Product Change Notification

Title: PCN #2023008 TDK-Lambda Americas Inc. HWS80A and HWS100A case dimension change

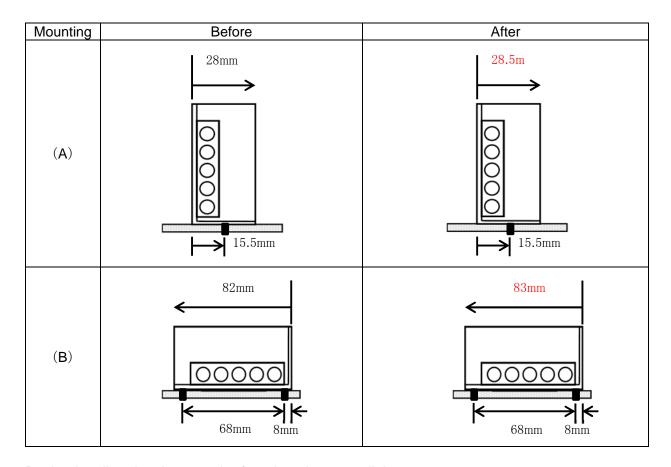
Please be informed that there will be small dimension increases to TDK-Lambda's HWS80A and HWS100A series of AC-DC power supplies. This will take place after October 2023 and is being implemented to improve vibration performance.

HWS80/100A	Before Change			After Change			
	Width (W)	Height (H)	Depth (D)	Width (W)	Height (H)	Depth (D)	
No cover	28	82	160	28.5	83	160.5	
With cover /A	33	82	160	33.5	83	160.5	
Tolerance +/- 1mm

Revised outline drawings can be found on these two links:
